UNITED STATES PATENT AND TRADEMARK OFFICE

APPLICATION NO.	FILING DATE	FIRST NAMED INVENTOR	ATTORNEY DOCKET NO.	CONFIRMATION NO.
10/584,813	06/27/2006	Toshiaki Kawanishi	930055-2045	4947

Office Action Summary	Application No. 10/584,813	Applicant(s) KAWANISHI ET AL.	
	Examiner SALLY A. SAKELARIS	Art Unit 1773

DETAILED ACTION

Fig.10 Structure of alcohol sensor

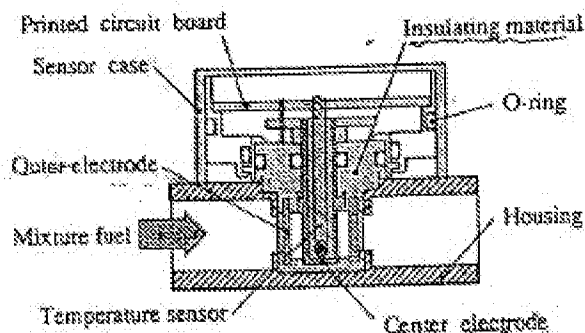
With regard to claim 8, Sanma et al. teach an alcohol concentration sensor of an electrostatic capacitance type for measuring an alcohol concentration in fuel for internal combustion engine mixed with alcohol in Figures 3 and in Figure 10 as can be seen below:

Sanma et al. teach that the sensor comprises: an insulating substrate and a pair of electrodes (Center and Outer) arranged on a surface of the insulating substrate capable of producing an electrostatic capacitance, wherein the insulating substrate is made of a material showing a low dielectric constant (i.e., discussion on pages 3 and 9 of their translation) in their taught insulating resin mold, substrate. Sanma et al. further teach a pair of lead out electrodes (i.e., leading out from the center and outer electrodes) that are exposed by the resin mold and configured such that they are capable of being brought into contact with the fuel mixed with alcohol for an internal combustion engine (see fuel mixture proximity in Figure 10 above).

With regard to claim 8, Sanma does not teach that the substrate has a thickness between 200 and 1000um, has a dielectric constant not higher than 5, that the pair of electrodes is at least partly covered by an insulated protective film showing a specific dielectric constant not higher than 5 or having a thickness between 0.4um and 1um.
